## РАЗЯСНЕНИЕ 1

към процедура на договаряне с обявление с предмет: **Доставка и въвеждане в експлоатация на система за непрекъснат он-лайн мониторинг на частичните разряди на 4 генератора в ТЕЦ КонтурГлобал Марица Изток 3, реф. № 28-51-15**

### Letter of Clarification 1

to public procurement procedure for negotiation with announcement with subject:  
**Supply and commissioning of a system for continuous on-line Partial Discharge Monitoring for 4 generators**  
in ContourGlobal Maritsa East 3 TPP, ref. No: 28-51-15

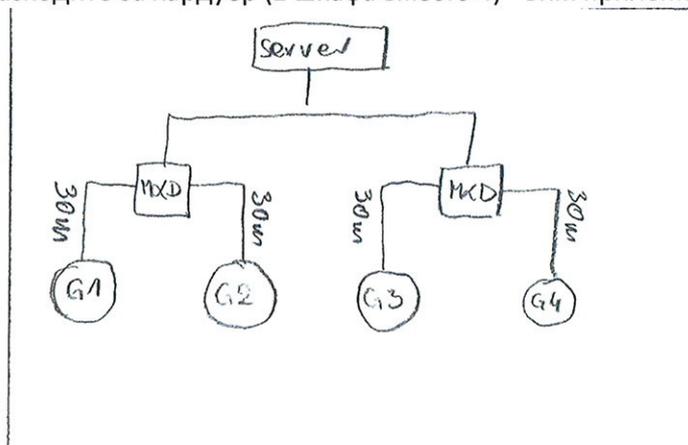
Възможно ли е да се постави шкаф на място, където разстоянието до клемните кутии на два генератора ще бъде по-малко от 30 m? Това няма да се отрази съответно на функционалността на системата, но ще помогне да се намалят разходите за хардуер (2 шкафа вместо 4) - виж приложения чертеж.

Като се има предвид, че физическите разстояния между съседните генератори са повече от 66 m и, че кабелите дори ще бъдат по-дълги от това, не е възможно да се постави шкаф, така, че клемните кутии на двата най-близки генератора да са на разстояние по-малко от 30 m.

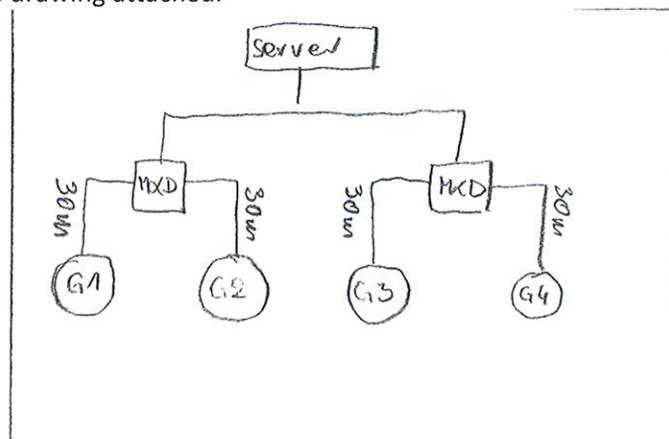
Is this possible to locate the cubicle in place where distance to terminal boxes of two generators will be less than 30 m? This is not affecting system functionality compliance, but helps to reduce the cost of hardware (2 cubicles instead of 4) - see drawing attached.

Given that the physical distances between the adjacent generators are more than 66 m, and that the cables will even be longer than that, it is not possible to locate the cubicles so that the two nearest generator terminal boxes are less than 30 m apart.
